**NW Natural Pre-Remedial Design Data Gaps Sampling  
B1 Navigation Channel Project Area – Fall 2020  
Field Change Request Form**

**Project Name:** B1 Navigation Channel Project Area      **Subconsultant:** Anchor QEA, LLC

**Field Activity:** Surface Sediment Sampling      **Request Number:** 1

**Field Change Request (FCR) Title:** Reoccupation of NewFields surface grab sampling locations within the Project Area

**Figure 1**  
**Proposed Additional Surface Grab Location (Downriver Portion)**

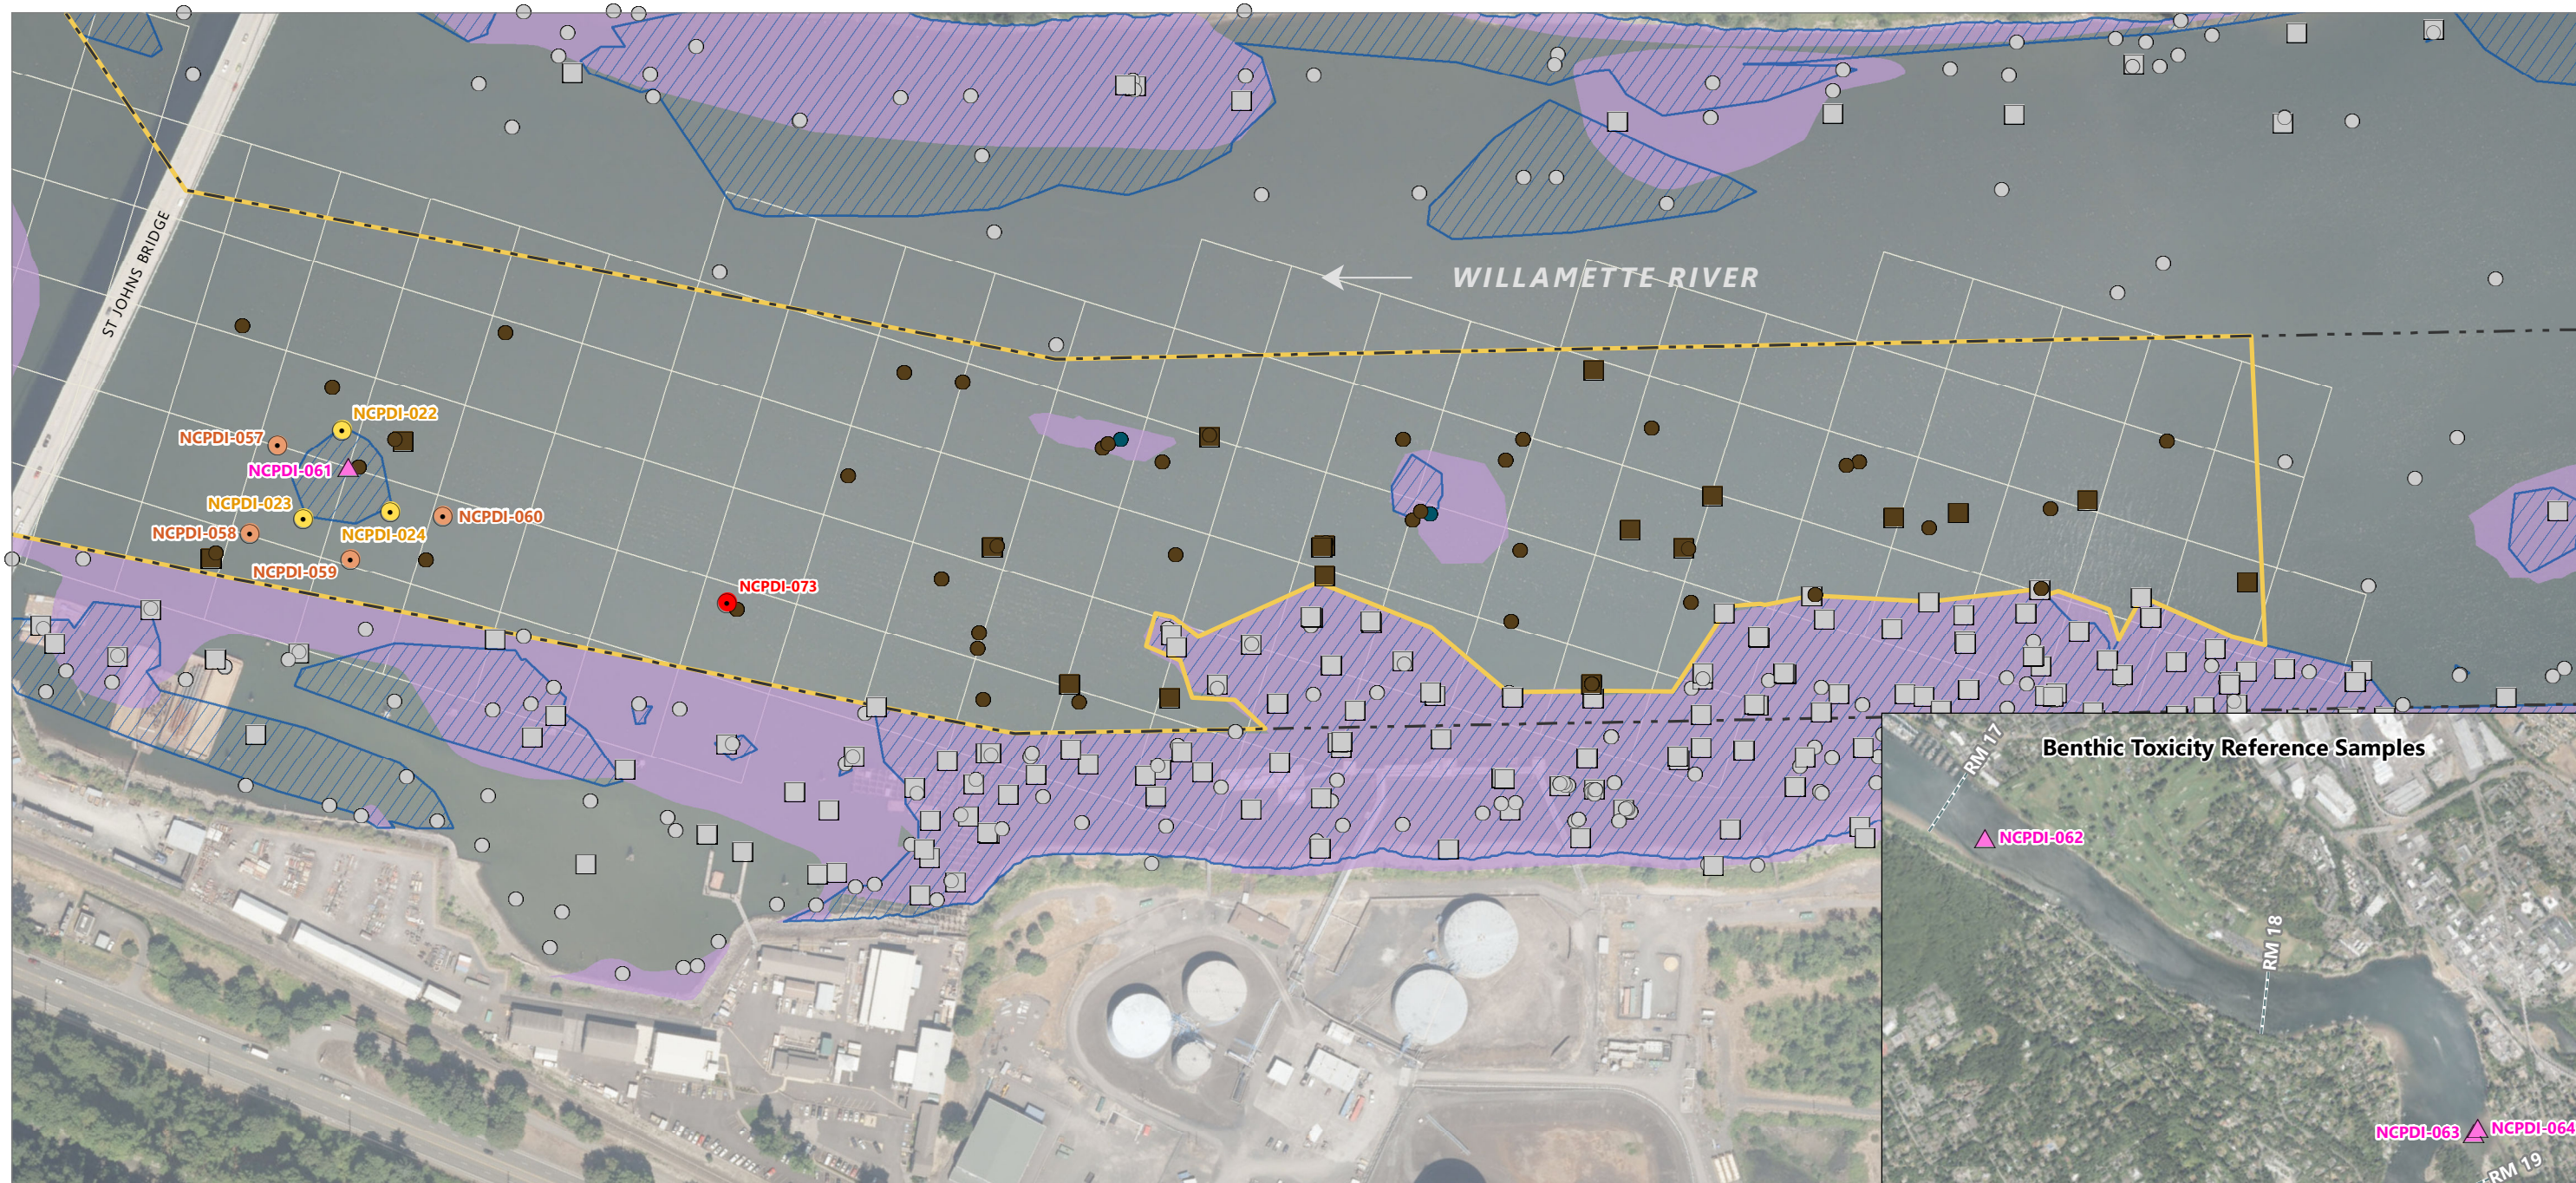
To satisfy EPA's request, NW Natural agrees to reoccupy the two NewFields sampling locations (PH15-23 and S-19) with locations NCPDI-072 and NCPDI-073. The additional surface (0 to 1 foot below mudline) sampling locations, shown in Figures 1 and 2, will be sampled and analyzed for comparison against the ROD 21 RALs and PTW-highly toxic thresholds consistent with the PDIWP. The location geographic coordinates are provided in Table 1. These co-located data, collected using unbiased, EPA-approved sampling methodologies performed under EPA oversight, will be used to support RD. The NewFields data will not be needed or used by NW Natural.
